Subject: Main Steam Check Valves
R. E. Ginna Nuclear Power Plant
Docket No. 50-244

In our letter to you of September 24, 1999, we responded to several questions arising from the NRC's Inspection Report 99-05. Within those responses, RG&E referenced a Duke Engineering and Services Report RG0007-T14-001, "Assessment of Main Steam Non-Return Check Valve Closure Analysis", Rev. 0.

Document No. RG0007-T14-001

Assessment of Main Steam Non-Return Check Valve Closure Analysis

FIGURE 1 - BREAK FLOW DISTRIBUTION

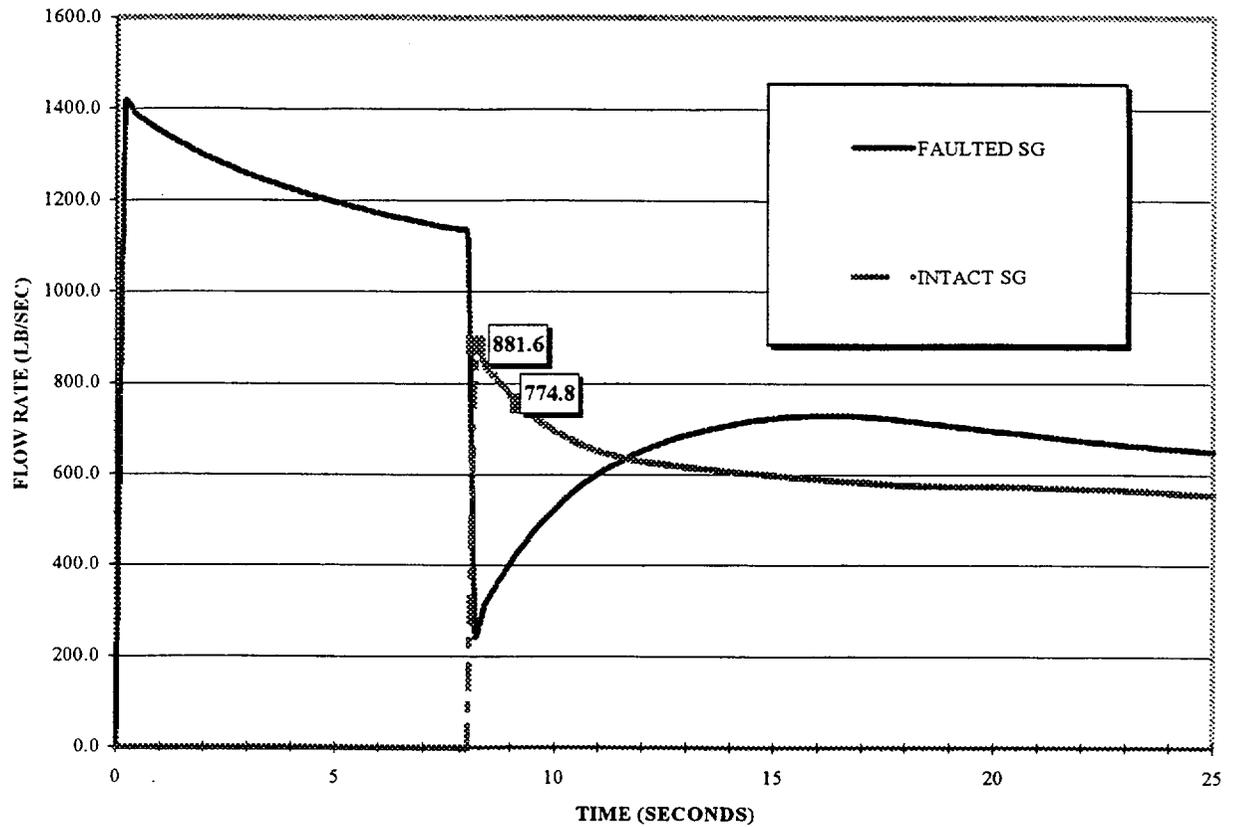
Transients always increase load results by large amounts. As can be seen in the Attachment B figure the flow at 8 seconds into the intact steam generator failure flow increases from essentially zero to 881.6 lbm/sec in less than 0.2 seconds. (This is a ramp speed of 4,408 lbm/sec².) This rate of change will increase the initial torque to start the valve closure motion strictly on the basis of a momentum transfer. This impact load will also add directly and significantly to the closing torque calculated by this or any other approach. Transient load application results are often 1.5 to 4 times greater than normal loads when the rate of loading is high. Although no direct test data was located to determine this effect, it is generally accepted that high rates of load application will increase, rather than decrease, the amount of torque generated.
